**VILLAGE OF VERNON HILLS
ORDINANCE 2024-021**

**AN ORDINANCE AMENDING ORDINANCE 2013-013 AND 2013-014, COLLECTIVELY THE
HAWTHORN MALL PUD, RELATED TO THE DEVELOPMENT OF YARD HOUSE
RESTAURANT WITH OUTDOOR DINING ON AN OUTLOT AT 950 N. MILWAUKEE
AVENUE**

Yard House Restaurant, 950 N. Milwaukee Avenue

Planning and Zoning Commission – Meeting Minutes
January 31, 2024 - 7:30 p.m.

EAST

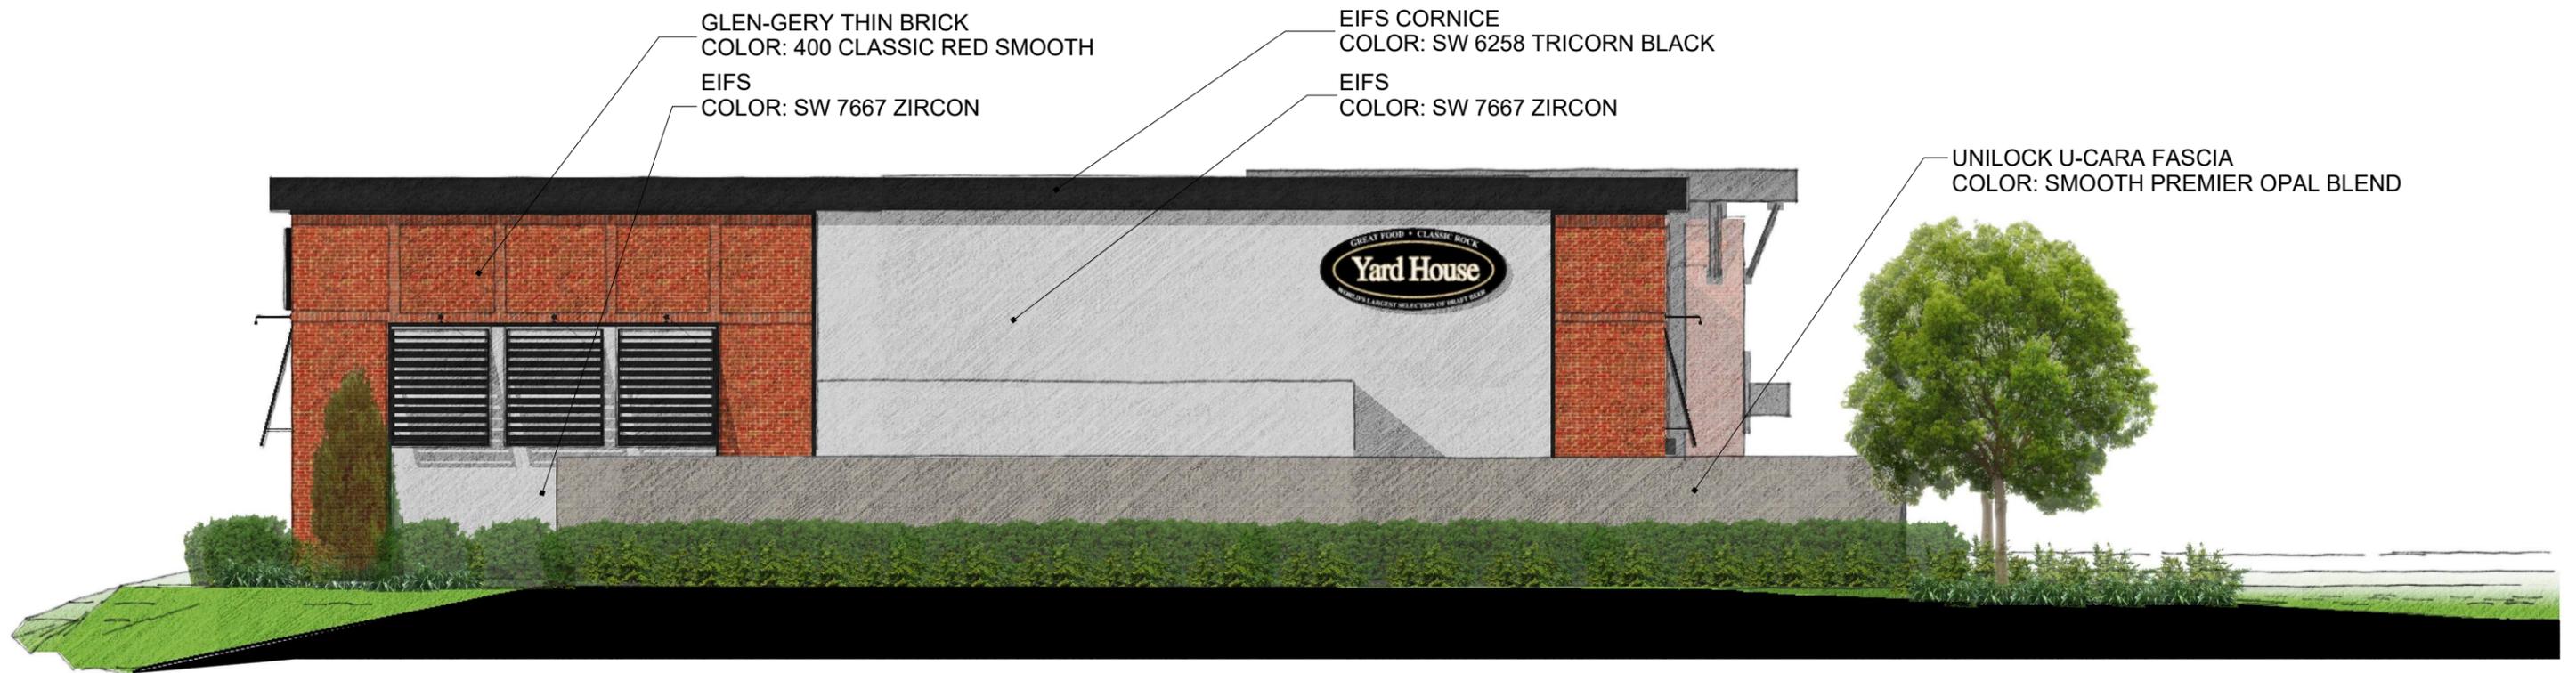
Commissioner Fluno referred to the east elevation. He noted that the trash enclosure and storage area screen wall was plain and appears to be missing a cap or a shadow line. Mr. Martin agreed that they could add a cap. Commissioner Fluno asked if they would consider ivy. Mr. Martin stated that they would prefer to keep the plantings along the foundation for maintenance reasons.

3. A cap shall be added to the trash enclosure and storage screen wall, and materials kept within area shall not exceed the height of the wall.
4. As the walk-in cooler extends above the height of the screen wall, the exterior appearance shall be modified if needed to blend with the screen wall or building wall.
